CHANGE
ORDER

PROJECT: Brookline High School

CHANGE ORDER NUMBER: 009

CONTRACT FOR: 3rd Floor Renovation & Quad Repairs

RE: T & M
RFI # 100

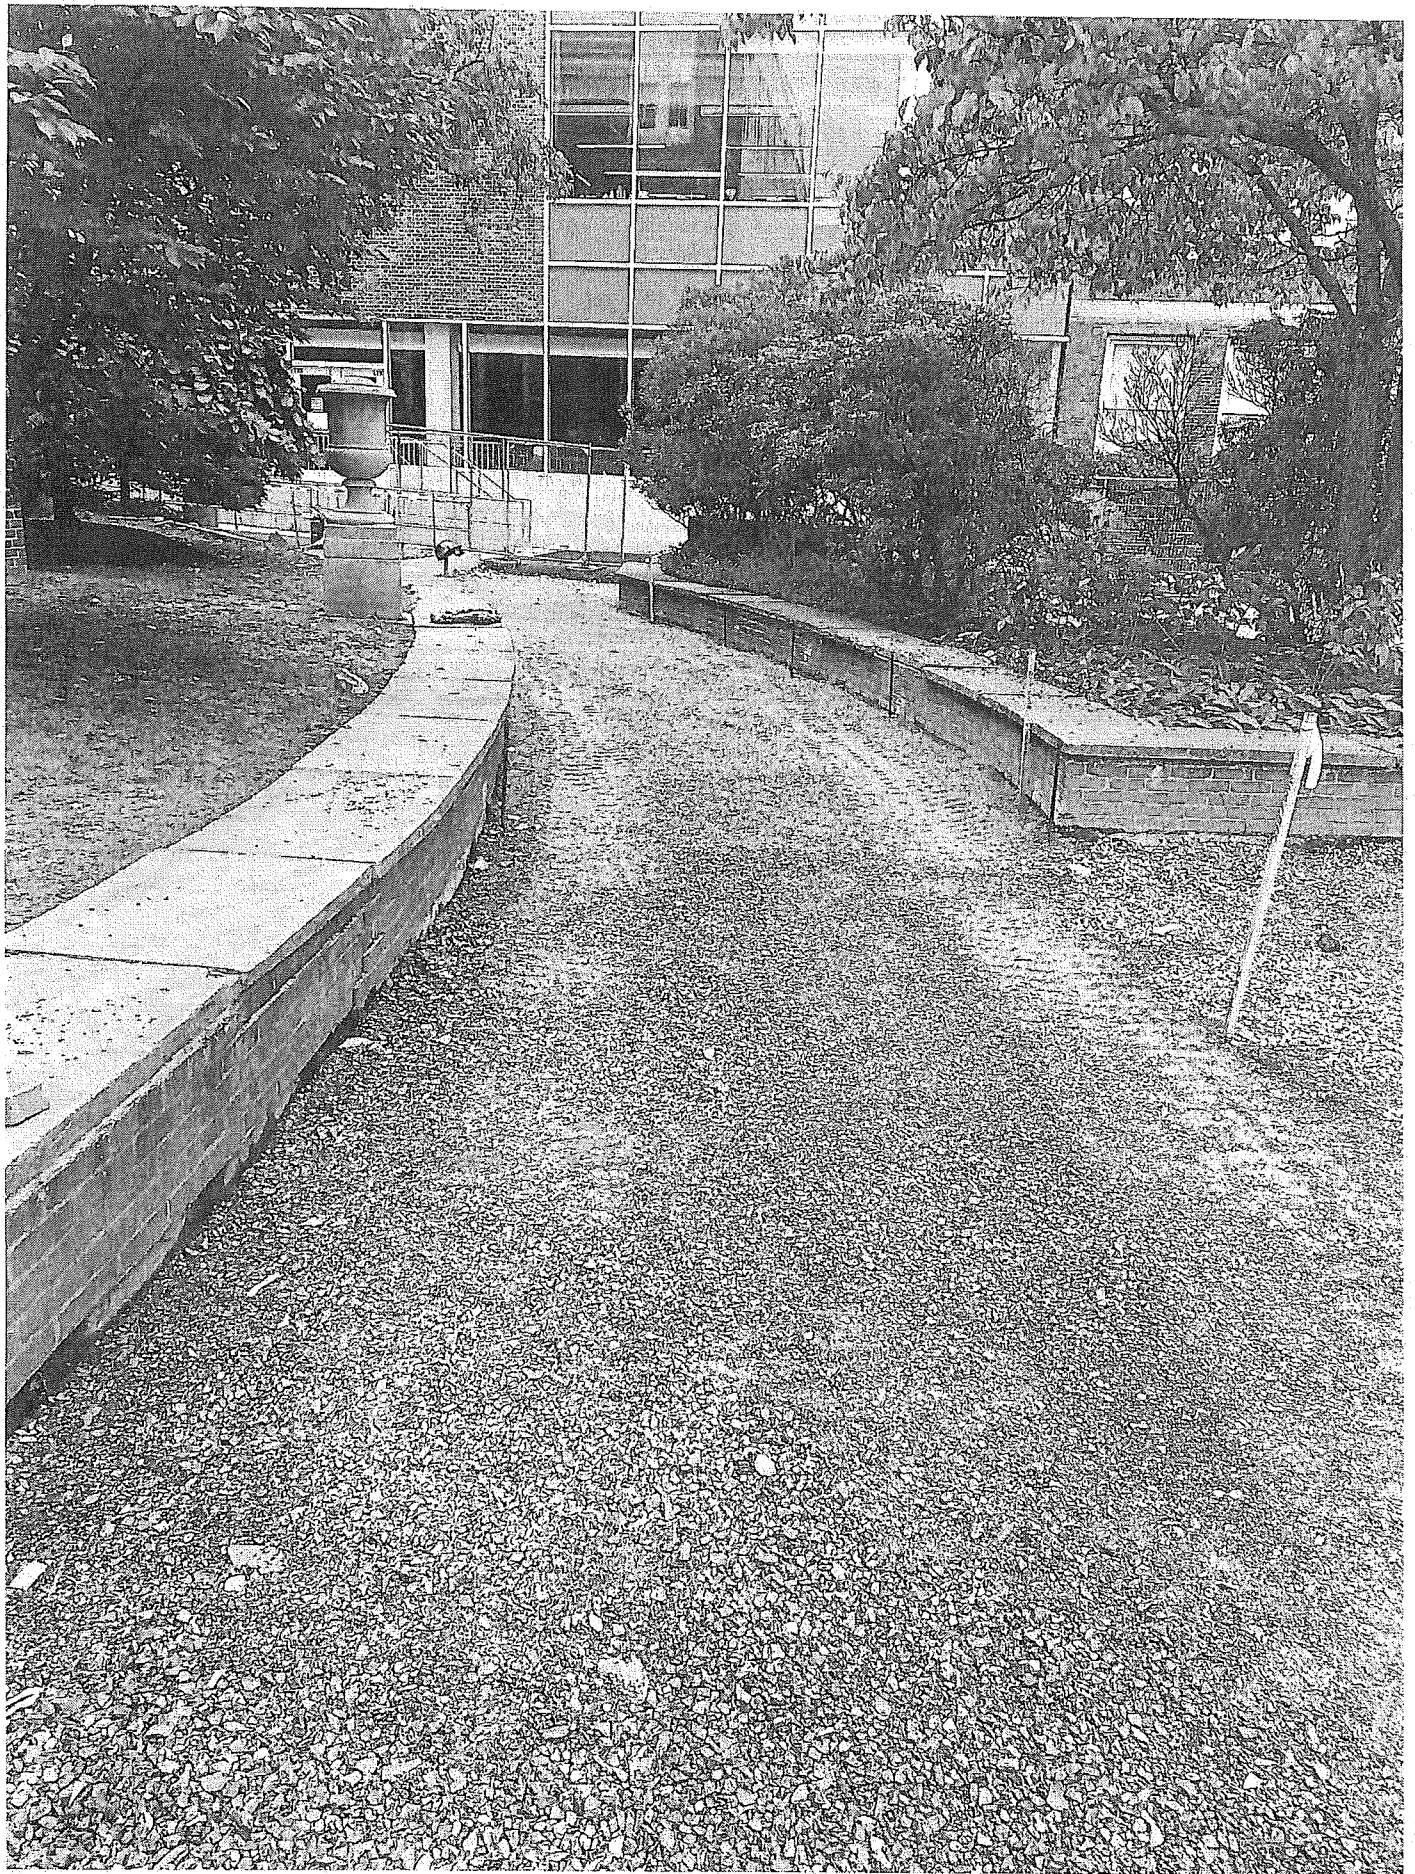
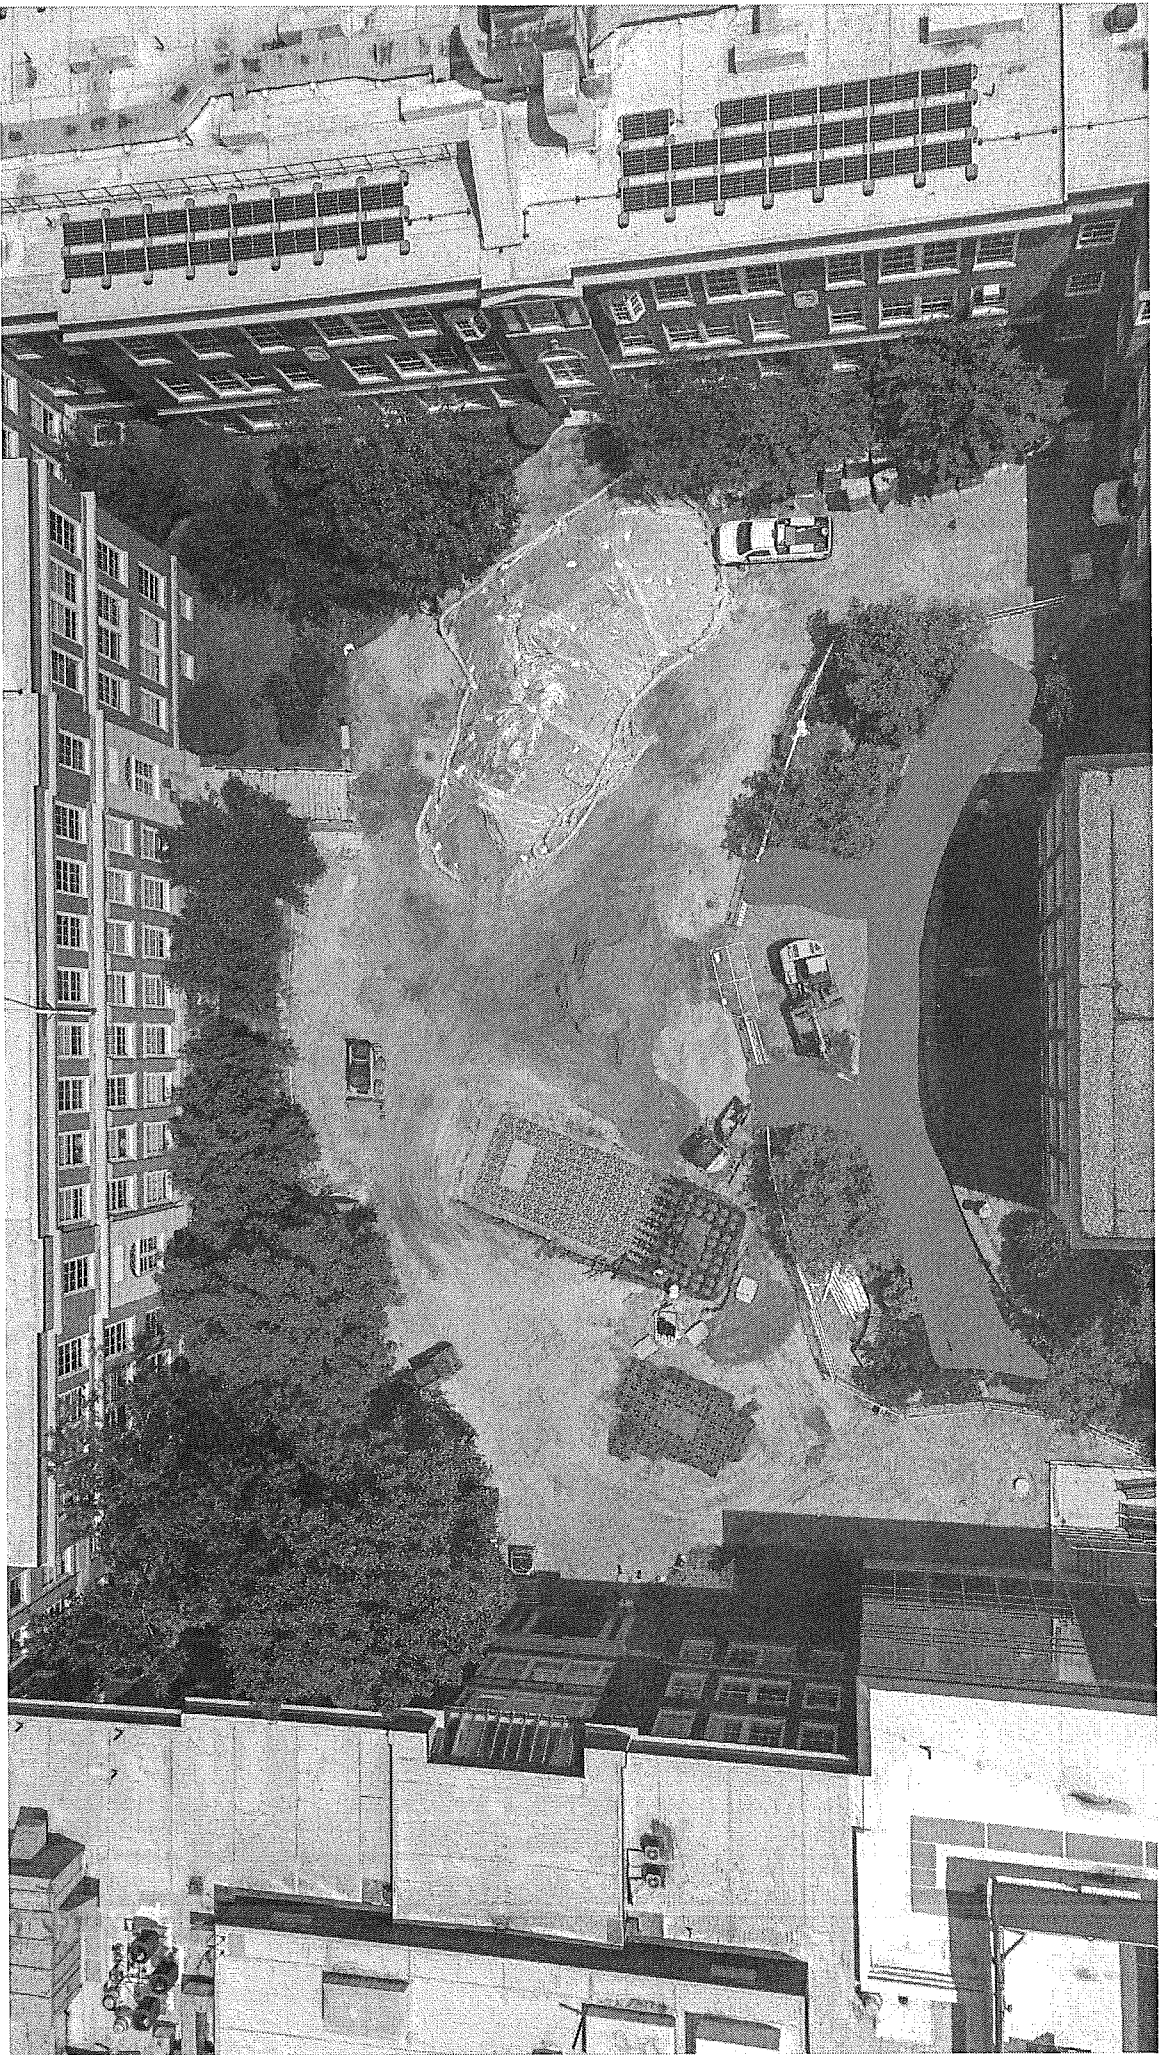
- 1.) Conway re-graded approx. ~~1500 SF~~ @ rear of planters (see attached drawing) per FB # 11
Was graded per original contract specs / plans

As discussed please see mark-up of area in question. The area is approx 1232sf

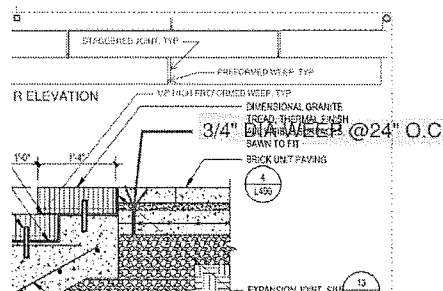
Provide preformed weeps at the bottom of each staggered tread joint.
Install vertical weeps, 6" behind back of granite treads.
